Access Compliance Report

Public Rights-of-Way

(Curb Ramps)

Intersection ID: 9739	Main Street: FAIRFIELD_ST	Cross Street: PATTON_AV	Location: W
ADA ID: E8837F1901A0	Ramp Type: PerpDiag	Initial Pass/Fail: Fail	Overall Compliance: No
			Severity Score: 33.75

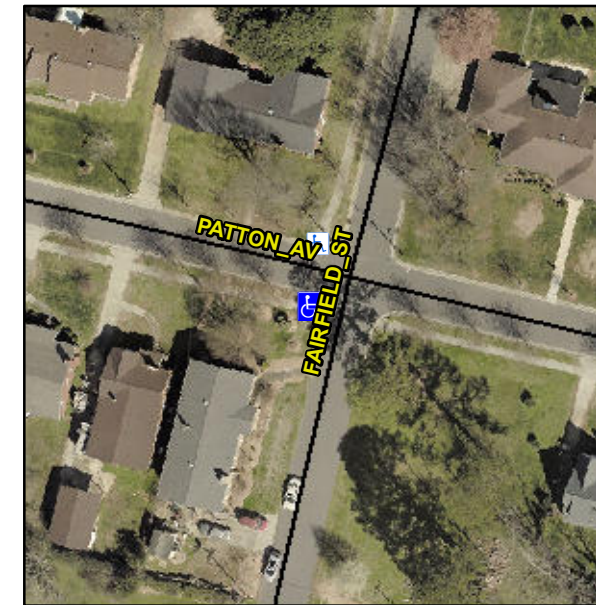
Not Found, R304.5.1, R304.5.3

Compliance	Description	Data	Compliance	Description	Data
N/A	Ramp Length (in)	110.0	Yes	Ramp Slope (%)	5.7
No	Ramp Width (in)	47.5	No	Ramp XSlope (%)	7.4
N/A	Flare Type LT	N/A	N/A	Flare Type RT	N/A
N/A	Flare Slope LT (%)	N/A	N/A	Flare Slope RT (%)	N/A
N/A	Flare Traversable LT?	N/A	N/A	Flare Traversable RT?	N/A
N/A	Landing Length (in)	N/A	N/A	DWS Provided?	N/A
N/A	Landing Width (in)	N/A	N/A	DWS Contrast?	N/A
N/A	Landing Slope (%)	N/A	N/A	DWS Length (in)	N/A
N/A	Landing X Slope (%)	N/A	N/A	DWS Full Width?	N/A
N/A	Landing Curb? (Y/N)	N/A	N/A	DWS Offset (in)	N/A
N/A	Shared Landing?	N/A			
N/A	Gutter Ponding?	N/A	N/A	Gutter Slope (%)	N/A
N/A	Gutter Lip Ht (in)	N/A	N/A	Gutter X Slope (%)	N/A
N/A	Painted X Walk1?	No	N/A	Painted X Walk2?	No
	X Walk 1 Direction	To SE		X Walk 2 Direction	To NE
N/A	X Walk 1 Width (in)	N/A	N/A	X Walk 2 Width (in)	N/A
	X Walk 1 Slope (%)	3.3		X Walk 2 Slope (%)	4.5
	X Walk 1 X Slope (%)	3.9		X Walk 2 X Slope (%)	4.1

Remove & Replace Curb Ramp With Two New Directional Ramps or Equivalent.
